Product / Process Change Notification (PCN)

PCN Number: PCN_FeSAFB_20241008

Affected Series: WE-SAFB, WE-AFB

Details of Change:

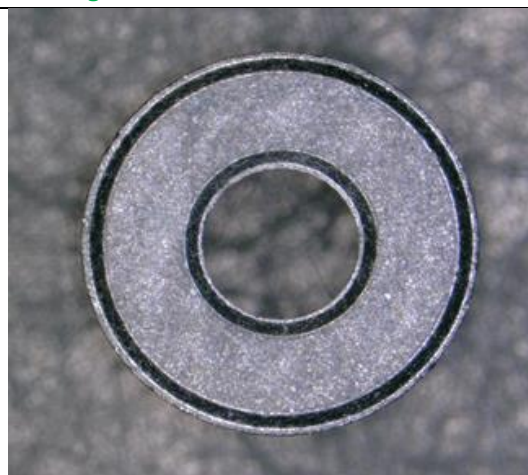
To meet current customer demands, Würth Elektronik eiSos will change the product border type. A chamfered edge has been added to avoid small cracks on the borders and to improve appearance. The detail of the change can be found on the table below with before and after pictures.
